ITEM DA - PLANNING REPORT - MOD2016/0075 (JRPP REF: 2016SYE073) TO DA2015/0332 (JRPP REF: 2015SYE114) - 17 MILLAR STREET DRUMMOYNE NSW 2047

Council City of Canada Bay

Modification Sought

S96(2) modifications to approved residential care facility including changes to internal building layout, external changes to built form including materials, colours, balconies, windows etc. and changes to landscaping and parking

REVISED PHOTOMONTAGE OF MILLAR STREET

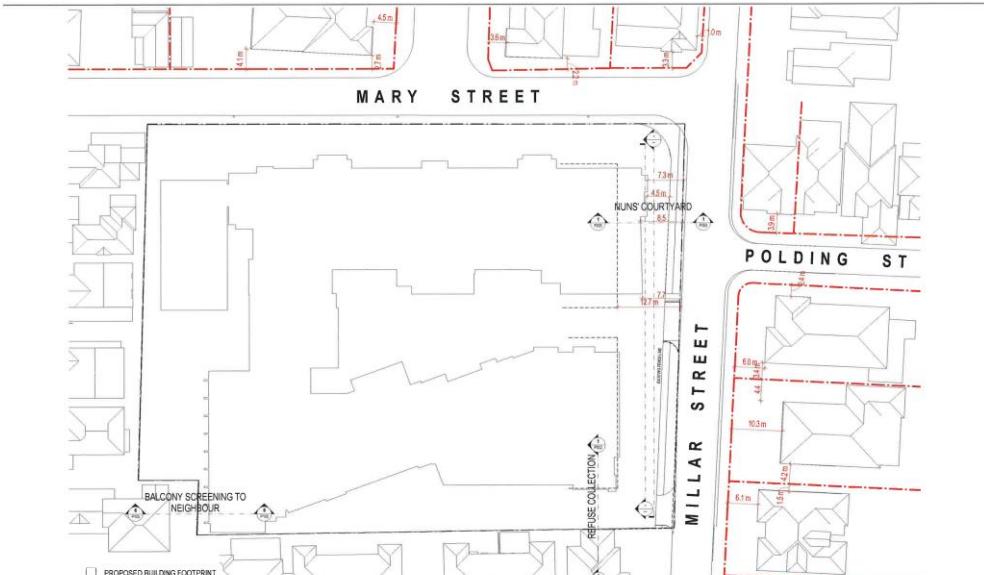
Comment: It is noted that any large area of the façade including off-white colour, which formed part of the initial s96 application plans as lodged and notified, will be finished with a more naturally toned colour (ref. Dulux Beige Royal). The replacement colour scheme formed part of the applicant’s revised modification application in response to concerns raised by Council that the large expanses of off-white façade elements within a predominantly naturally toned low density streetscape was inappropriate.
